UNITED STATES PATENT AND TRADEMARK OFFICE

10/799,143

Lutz Biedermann

Office Action Summary	Application No. 10/799,143	Applicant(s) BIEDERMANN ET AL.	
	Examiner MARY HOFFMAN	Art Unit 3733

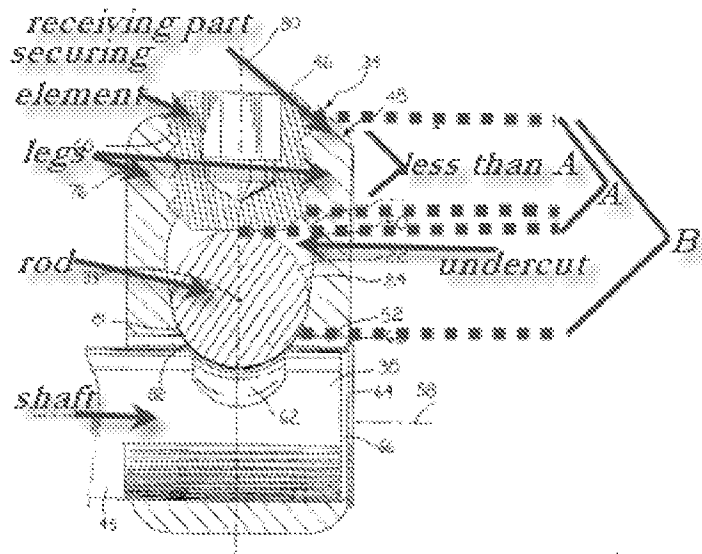
Claims 1, 2, 7, 21, 22 and 27 are rejected under 35 U.S.C. 102(b) as being anticipated by Krag (US 6,231,575), cited by Applicant.

Krag discloses an anchoring element (See FIG. 7 and marked up figure below) for use in spinal or bone surgery; the anchoring element comprising: a shaft for anchoring in a vertebra or a bone section; a rod having a pre-determined diameter (D) and an outer surface; a receiving part, which is connected to the shaft and is structured and arranged to connect to the rod, the receiving part having a longitudinal axis and

comprising a U-shaped recess forming a channel for the reception of the rod and two legs having free ends, the legs comprising a first internal thread, the legs further providing an exterior end surface of the receiving part; and a securing element comprising a screw member having a first external thread that engages and cooperates with the first internal thread; whereby a first distance from the exterior end surface of the receiving part to a closest portion of the outer surface of the rod in an axial direction is a pre-determined distance (A); the first internal thread extending from the exterior end surface of the receiving part to a second distance that is smaller than or equal to the pre-determined distance (A); and the receiving part further comprising an undercut (*i.e.* a cut made in a lower part: a cut made below another cut or into the lower part of something- see Encarta® World English Dictionary, North American Edition online for definition) extending circumferentially and the first internal thread extending to the undercut, the undercut having an edge farthest away from the first internal thread, the edge being located at a third distance (B) from the exterior end surface, the distance (B) being larger than the predetermined distance (A).

The first internal thread extends into the undercut. The securing element contacts the rod. The undercut has a depth that corresponds at least to the depth of the first internal thread. A connection between the shaft and the receiving part is structured and arranged to be a monoaxial connection.
